SUBJECT: Submittal of Responses to NRC Requests for Additional Information for the Environmental Review of the Three Mile Island Unit 2 Independent Spent Fuel Storage Installation License Renewal Application, Docket 72-0020 (EM-NRC-17-037)

**Responses to NRC Request for Additional Information on the
TMI-2 ISFSI License Renewal Application Environmental Report Supplement**

**Figure ER-7-1
Meteorological Station Locations on DOE's Idaho Site**

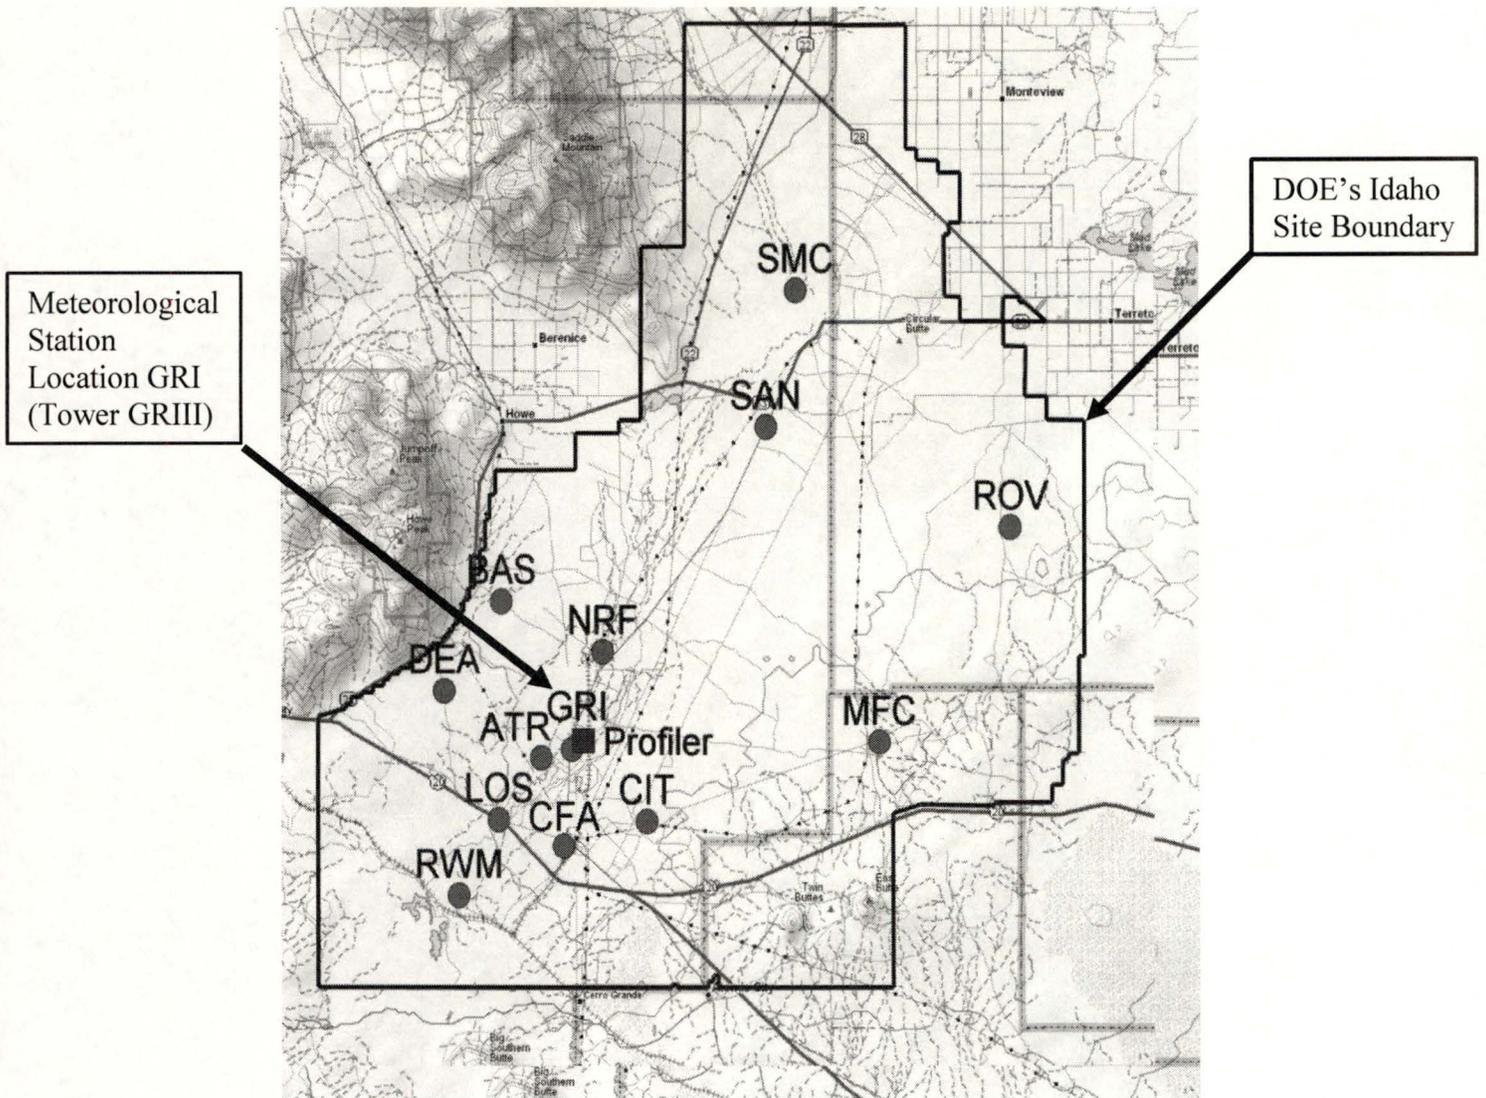
Provide the location where wind data in Table 2-5, "Wind Speed Means and Extremes for 10 Meter Tower Level at GRI," was recorded, and define "GRI."

Supplemental ER Section 2.3, "Climatology and Meteorology," discusses wind speeds at GRI. This location is not defined.

Grid III is a meteorological monitoring tower (GRI). The meteorological stations on DOE's Idaho site are shown on Figure ER-7-1 below. Meteorological Station Location GRI, used for the TMI-2 ISFSI data, is the location of the Grid III meteorological tower. GRI is located approximately one mile (1.6 km) north of INTEC. The TMI-2 ISFSI is located approximately one-half mile (0.8 km) from the northern INTEC boundary, in the southern center of the INTEC site (see LRA Figure 3-1)
